MDS SELF-STORAGE

RE: Mesa Del Sol Self Storage 5500 Turing Dr. SE Grading and Drainage Plan Engineer's Stamp Date: 5/7/2025 Hydrology File: R16DA1004

Re: Mesa Del Sol Self Storage 2322 Mesa del Sol SE Traffic Circulation Layout

MESA DEL SOL ARCHITECTURAL CONTROL COMMITTEE SITE DEVELOPMENT PLAN REVIEW

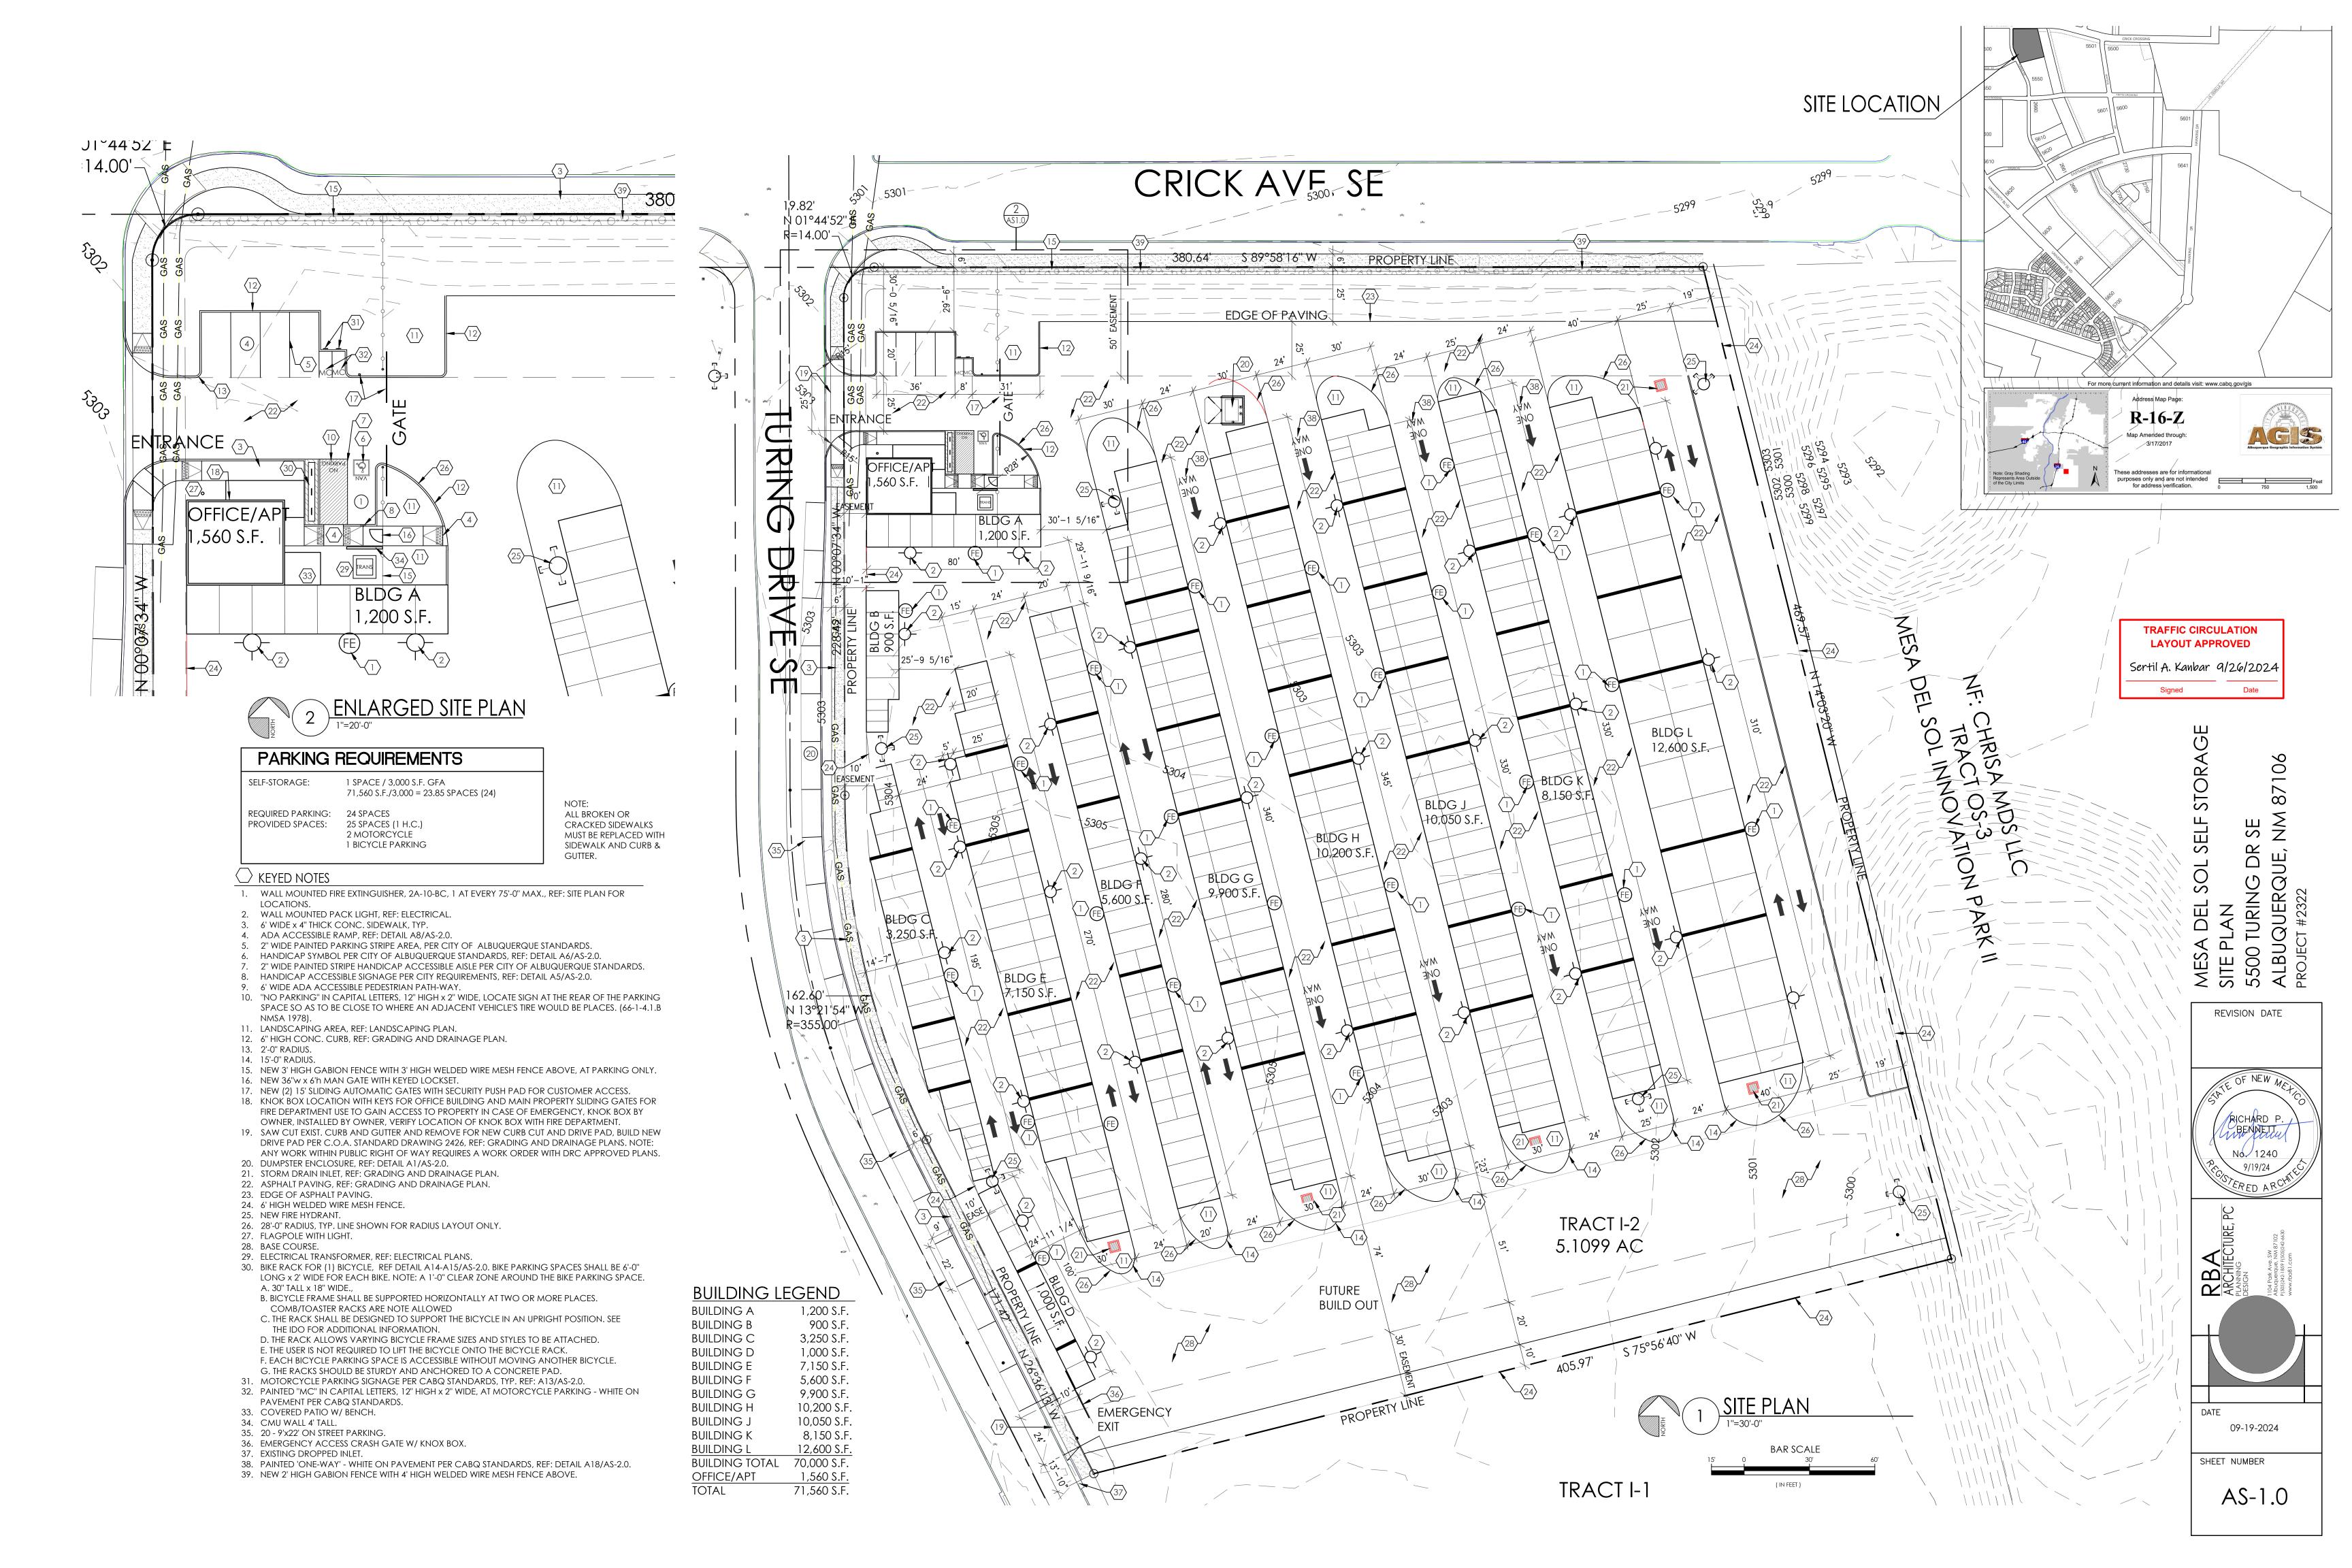
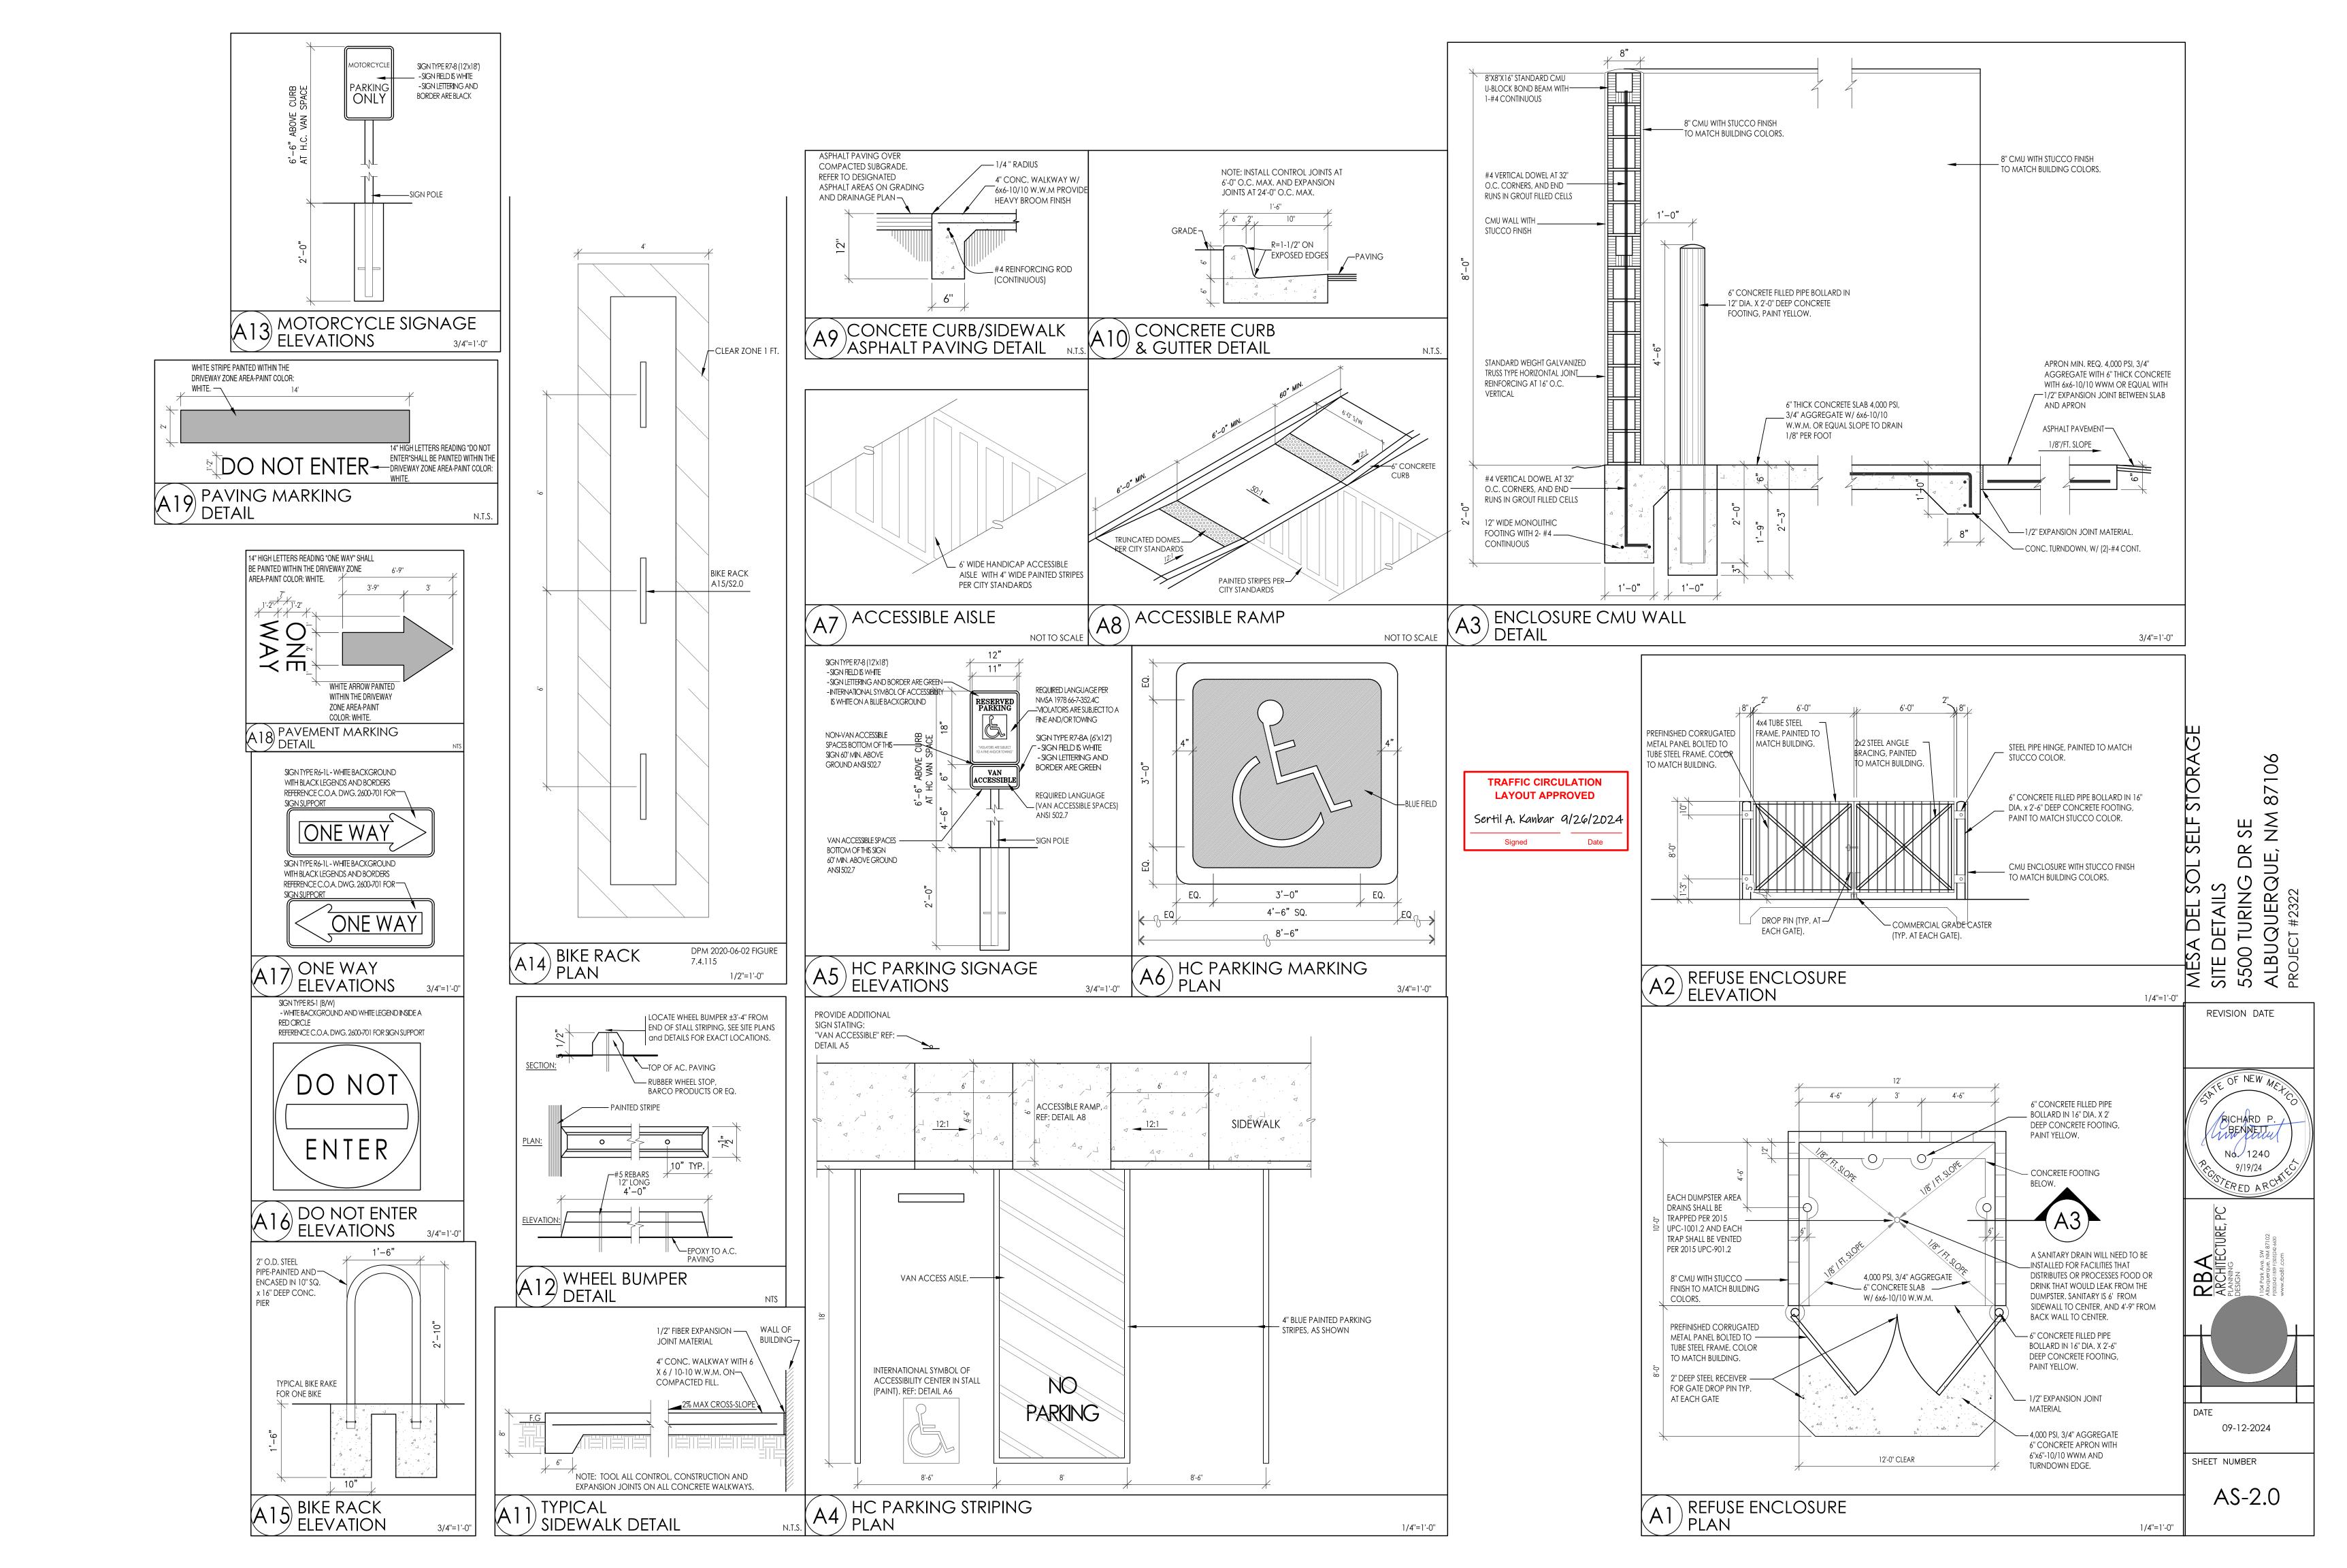
The TCL submittal received 9-23-2024 is approved for Building Permit by Transportation. A copy of the stamped and signed plan will be needed for each of the building permit plans. Please keep the original to be used for certification of the site for final C.O. for Transportation.

When the site construction is completed and an inspection for Certificate of Occupancy (C.O.) is requested, use the original City stamped approved TCL for certification. Redline any minor changes and adjustments that were made in the field. A NM registered architect or engineer must stamp, sign, and date the certification TCL along with indicating that the development was built in "substantial compliance" with the TCL. Submit this certification, the TCL, and a completed <u>Drainage and Transportation Information Sheet</u> to the <u>PLNDRS@cabq.gov</u> for log in and evaluation by Transportation.
